DUKE POWER COMPANY  
OCONEE NUCLEAR STATION  
CORE THERMAL-HYDRAULIC METHODOLOGY  
USING VIPRE-01

Revision 1 Submitted: February 2000

Subject: Oconee Nuclear Station, Docket Numbers 50-269, -270, and -287  
Topical Report EPC-NE-2003, "Core Thermal-Hydraulic Methodology  
Using VIPRE-01"; Response To Request For Additional Information

FIGURE 1.

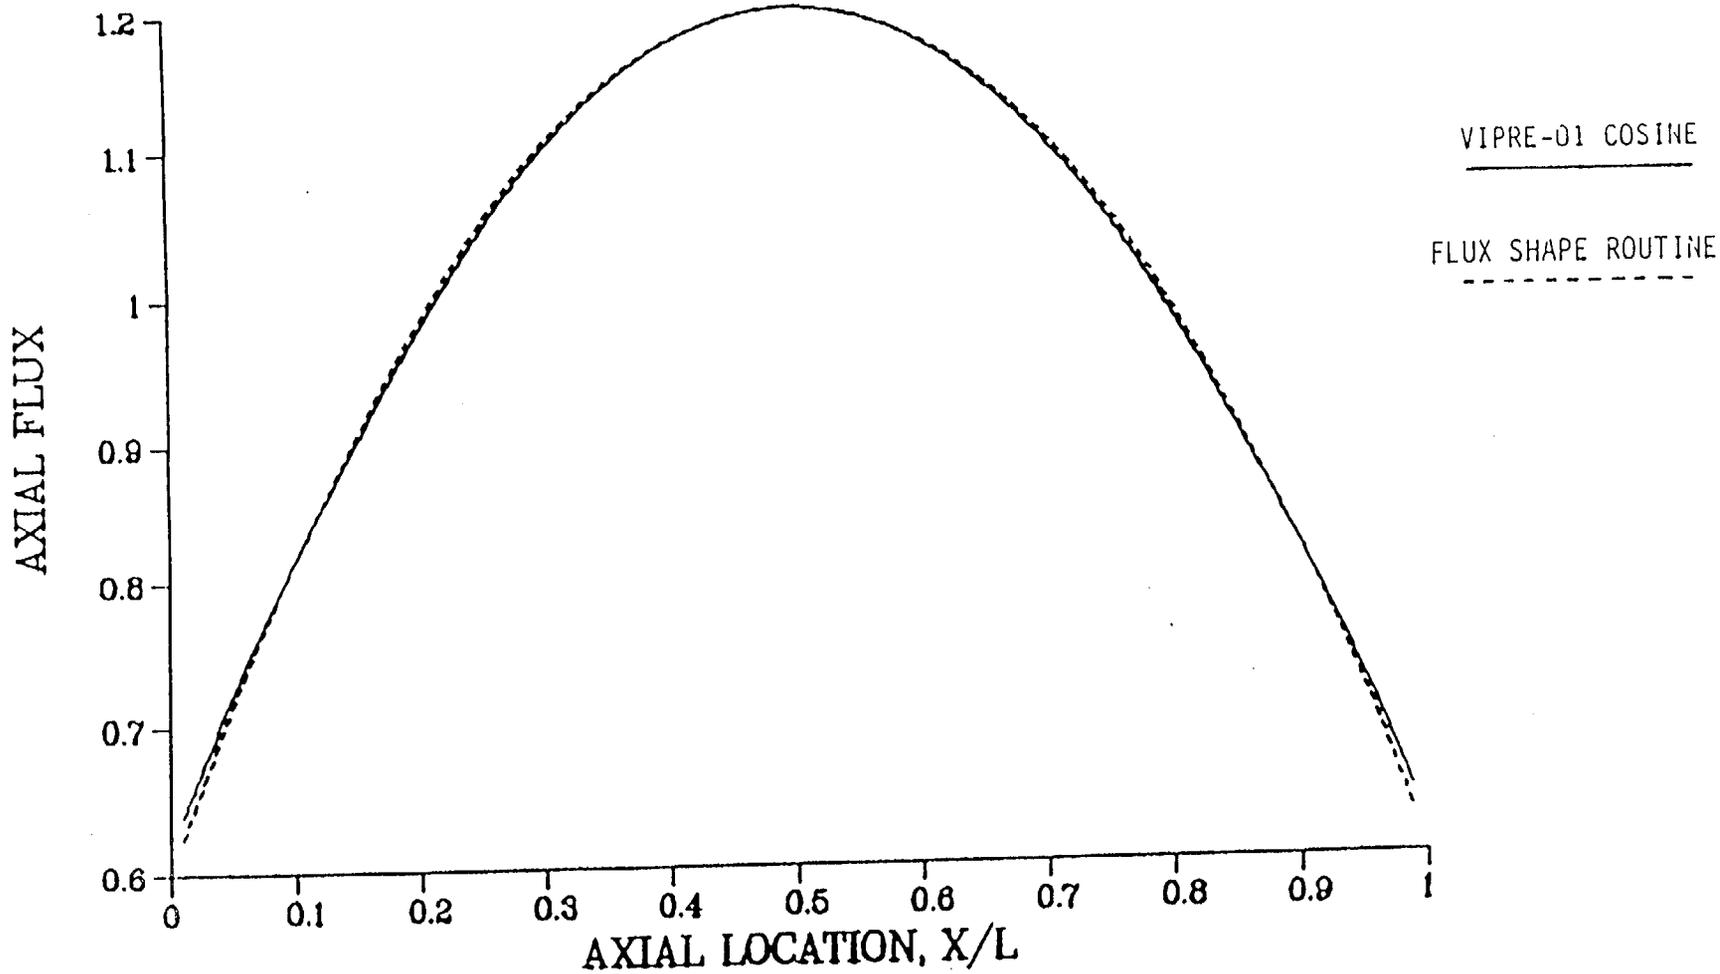
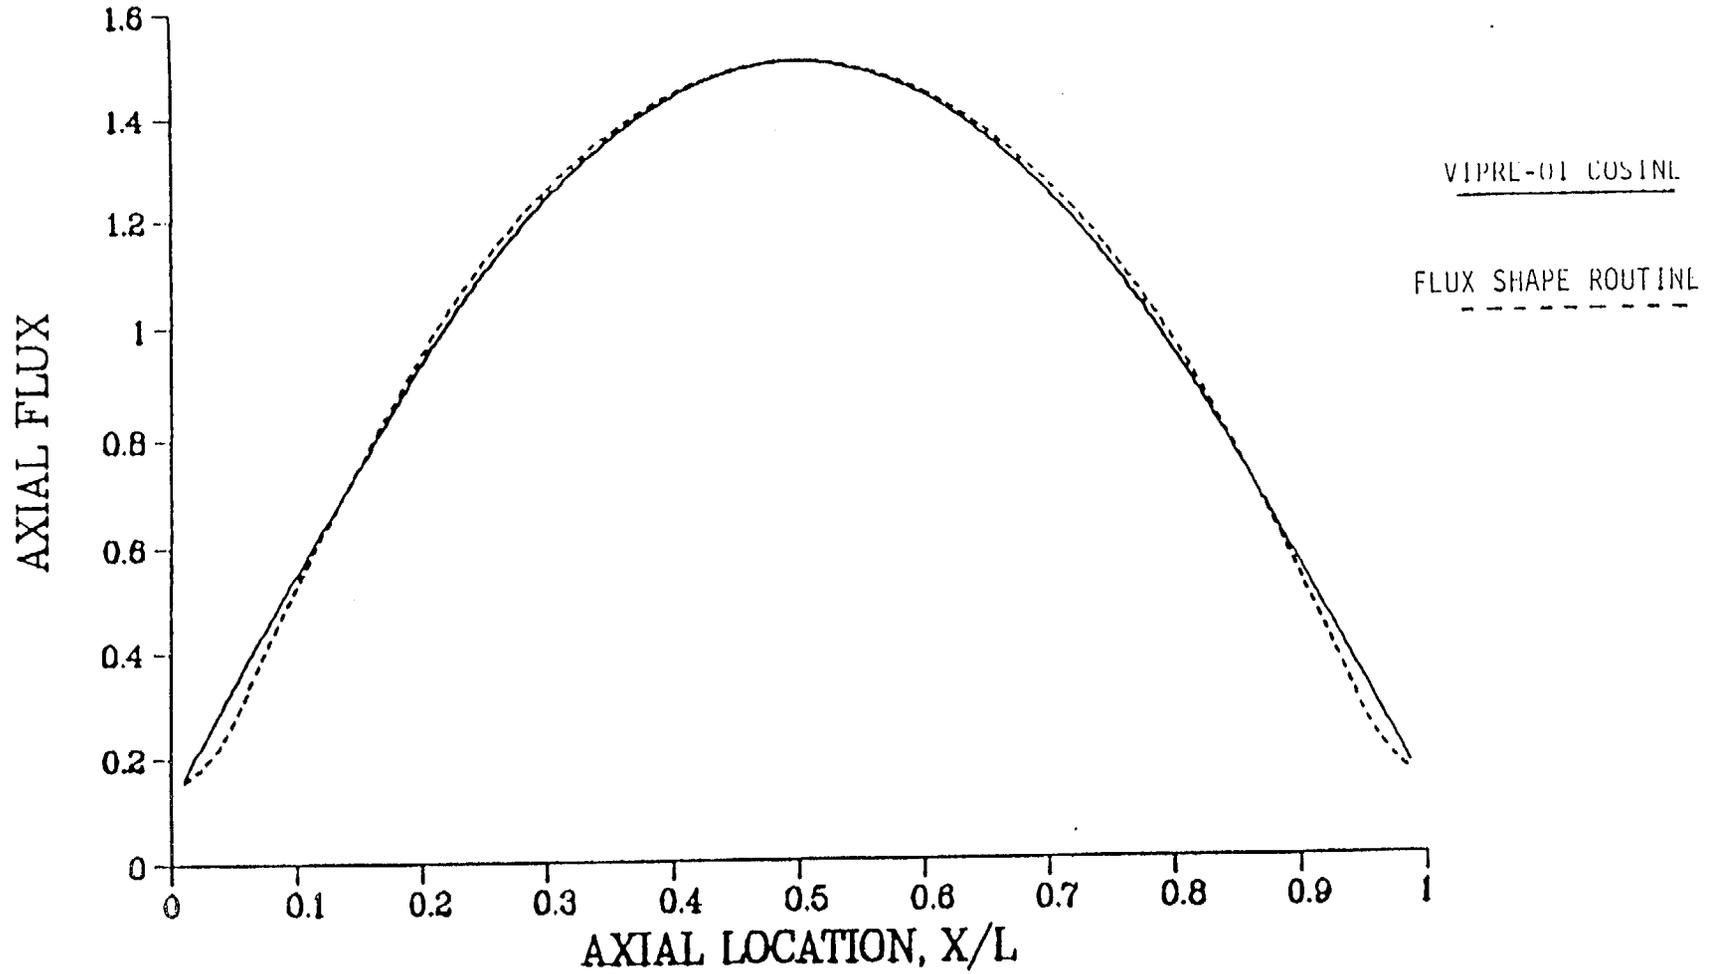
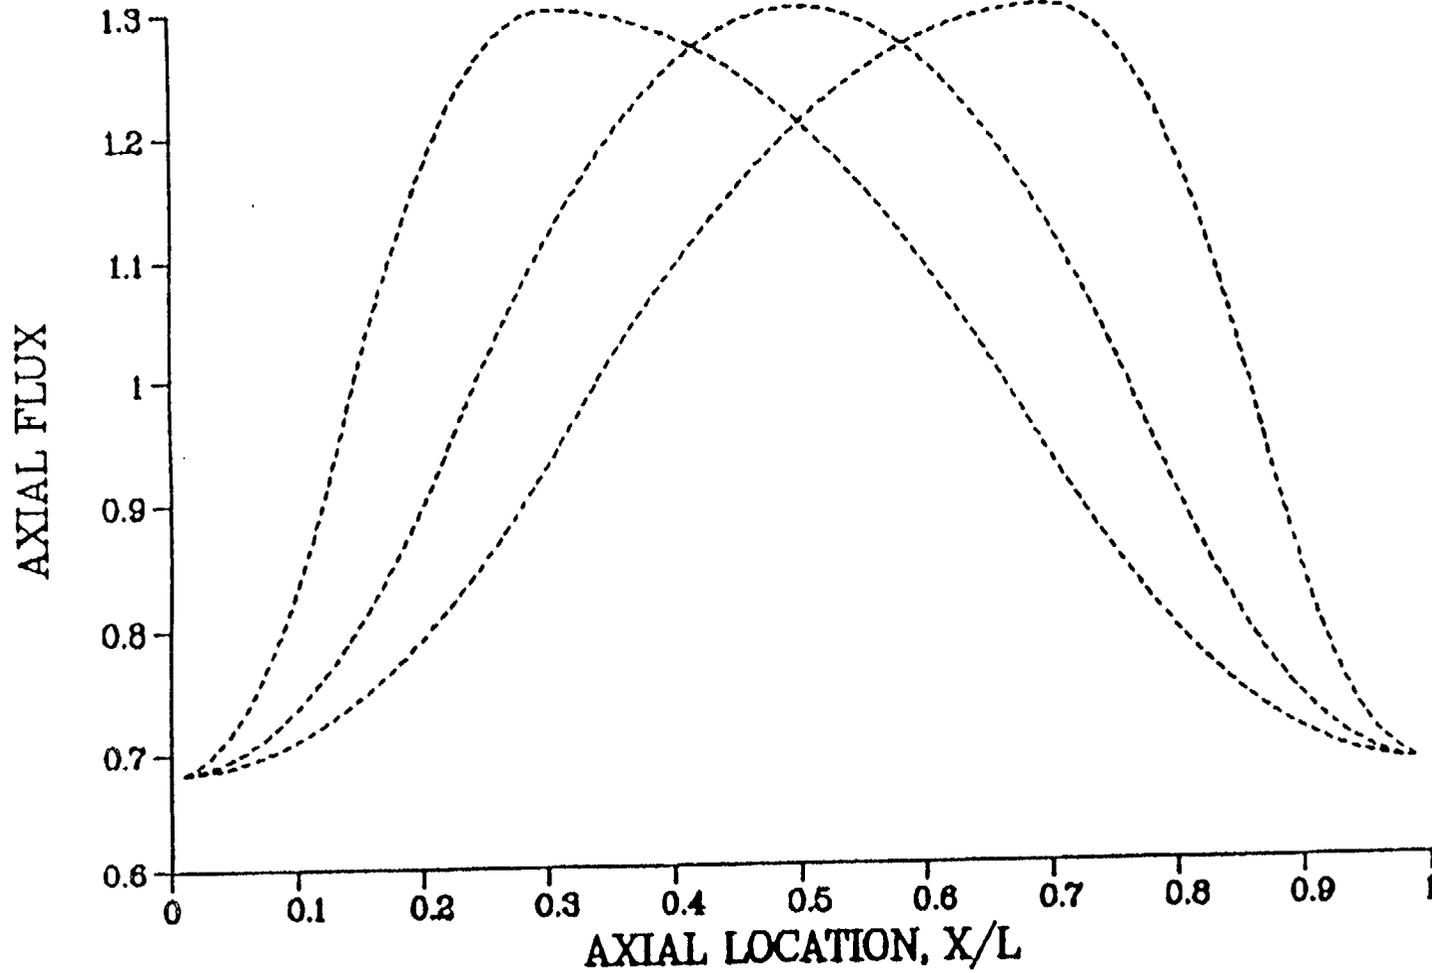
Section 5.10 states that a new routine is added to the VIPRE-01 code to generate axial power shapes with inlet, symmetric, or outlet peaks. Provide sufficient details of this routine.

The axial power shape routine added to VIPRE-01 is based on the following mathematical constraints on an axial power shape:

figures clearly show the agreement between the two methods of generating symmetric axial flux shapes. The new flux shape routine was added to generate skewed axial flux shapes. As discussed in Section 6.5 of the topical report, Maximum Allowable Peaking (MAP) limits are calculated for a range of axial peaks with the location of the peak varied from the bottom to the top of the core. As an example of the flux shapes used to calculate the MAP limits, three axial shapes are shown in Figure 3 for an axial peak of 1.3 at  $X/L = 0.3, 0.5, \text{ and } 0.7$ .
